UNITED STATES  
NUCLEAR REGULATORY COMMISSION  
WASHINGTON, D.C. 20555-0001

SUBJECT: AEROTEST OPERATIONS, INC. – ISSUANCE OF AMENDMENT NO. 6 RE:  
PERMANENTLY DEFUELED TECHNICAL SPECIFICATIONS AND PARTIAL  
DENIAL OF AMENDMENT REQUEST (EPID NO. L-2019-LLA-0065)

SAFETY EVALUATION BY THE OFFICE OF NUCLEAR REACTOR REGULATION

Figure 1 – ARRR ANSI/ANS-15.1 Organization

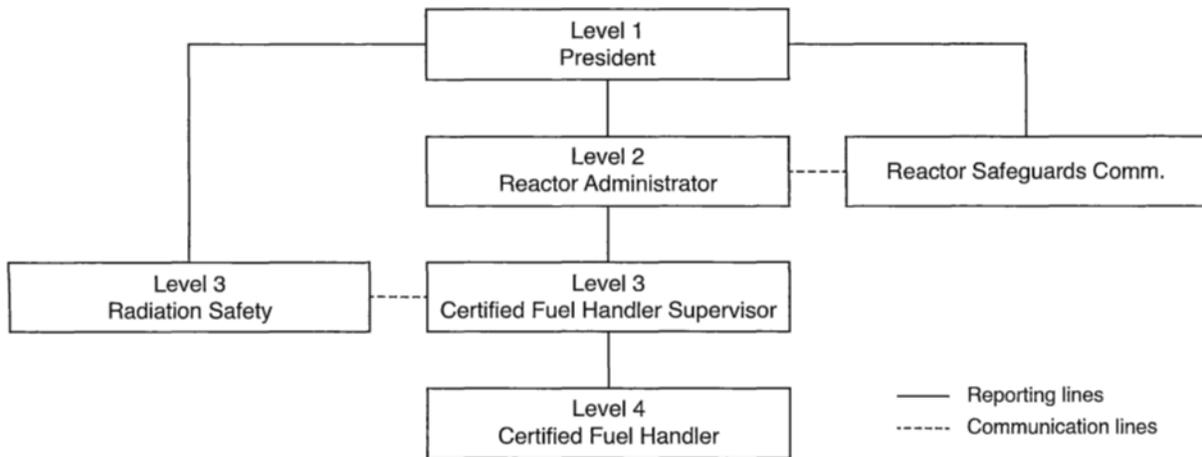
In its April 28, 2021, response to RAI 15 and in its June 22, 2021, response to draft RAI 15.1.3, the licensee proposed to add TS Figure 1 to illustrate the ARRR organization reporting and communication lines.

The NRC staff reviewed proposed TS Figure 1 and finds that it is sufficiently consistent with the guidance provided in NUREG-1537, Part 1, Appendix 14.1, as well as ANSI/ANS-15.1-2007, Chapter 6, Figure 1, "Organization Chart," which illustrates organizational Levels 1 through 4 and their reporting and communication lines. The NRC staff also finds that proposed TS Figure 1 is consistent with the requirements and organization description in proposed TS 12.0. Based on the above, the NRC staff concludes that proposed TS Figure 1 is acceptable.
